IN THE DRAWINGS:

REMARKS

ITEM 1: OBJECTION TO THE DRAWINGS

FIG. 1
(PRIOR ART)

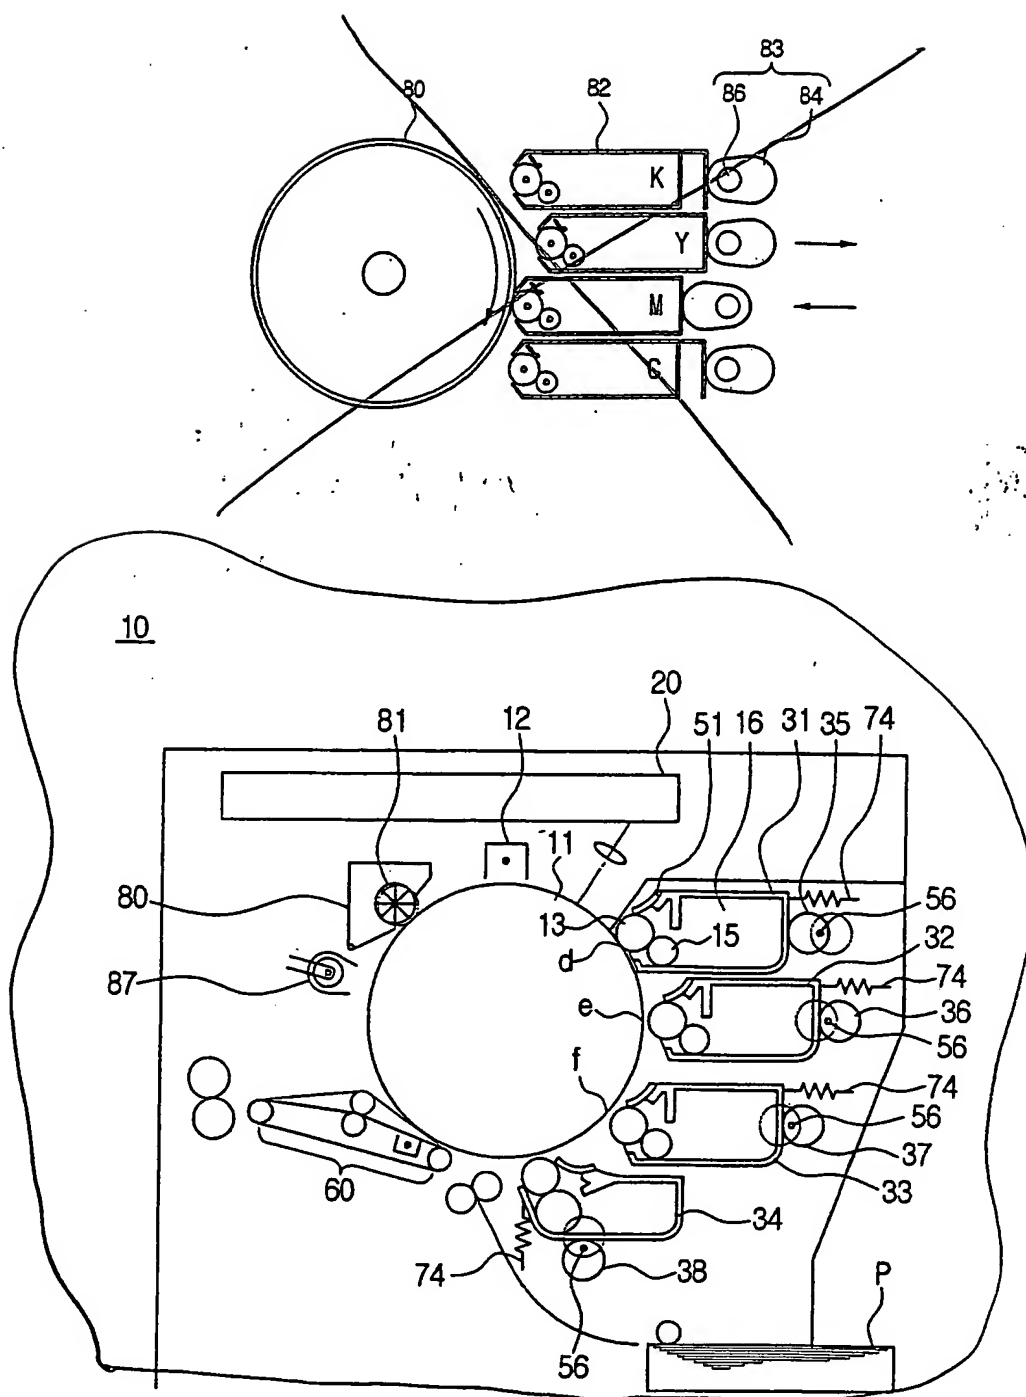
In the Office Action at item 1, the Examiner objected to the drawings in that they failed to match up to the reference parts as described in the specification. In order to overcome this objections, replacement figures are submitted herewith. Replacement FIGs. 1, 2, 3, 4, and 5 correspond to the reference parts as described in the specification.

In item 1, the Examiner objects to the drawings under 37 CFR 1.83(a) because they fail to match up with reference parts as described in the specification. FIGS. 1-5 are amended herein to provide drawings that provide views that match up to the reference parts as described in the specification. See, for example, paragraphs [0003]-[0018] and paragraphs [0050]-[0070].

The attached drawing(s) include changes to FIGS. 1, 2, 3, 4, and 5. The sheets containing FIGs. 1, 2, 3, 4, and 5 replace the respective original sheets including FIGs. 1, 2, 3, 4, and 5.
